B01-2015_BFL-EN

Fast Lock Coils

RE: New Coils “FAST LOCK” series HF2 and HF3

Picture n.1 New Coil “FAST LOCK”

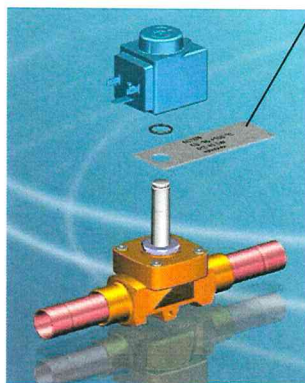
The part number of the solenoid valve currently reported on the yellow cap will be printed by laser on the armature (only series 1020 and 1028, see picture n.1), making the information indelible and durable as well as to ensure traceability. All the others normally closed solenoid valves will be supplied with the tear resistance label (see picture n. 2).

Printed by laser
1020/..
1028/..

Picture n.2 New Coil “FAST LOCK”

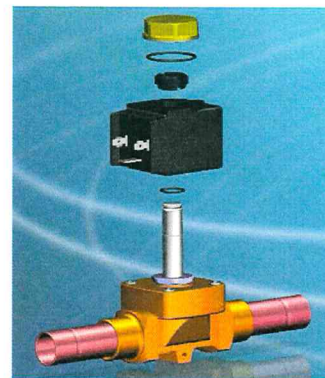
Tear resistance
1064/..1068/..
1078/..1079/..
1098/..1099/..
